OLD NINO INPUT

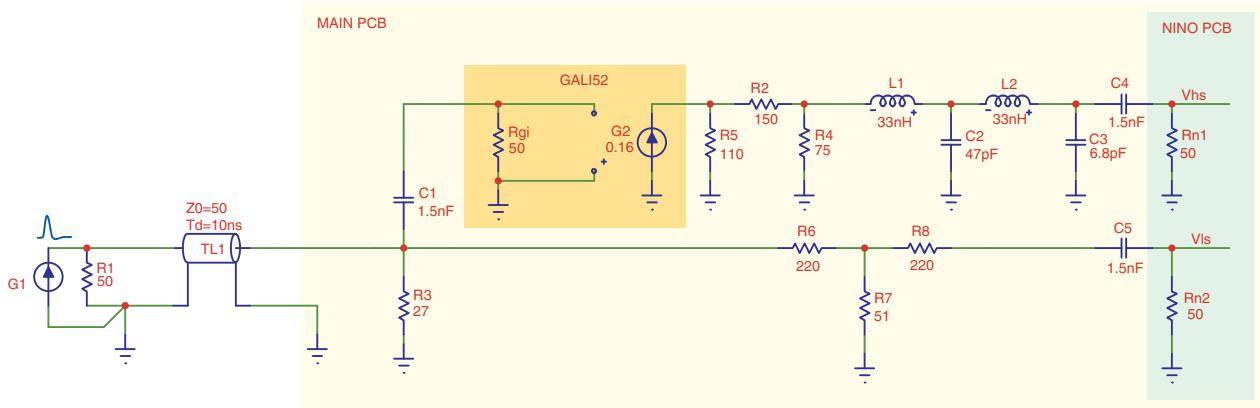
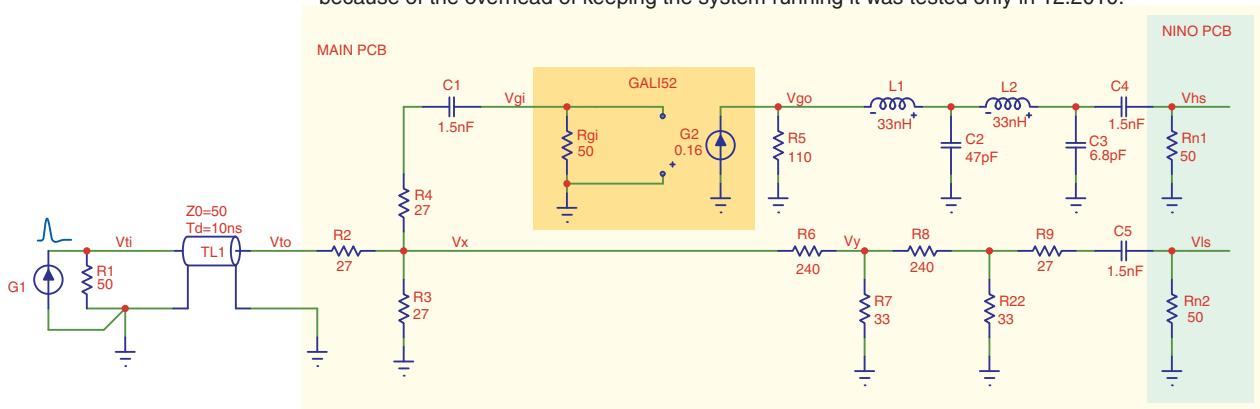
Difference: The attenuation from the GALI output has been moved to the input, and another resistive divider has been added to the low-sensitivity attenuation.
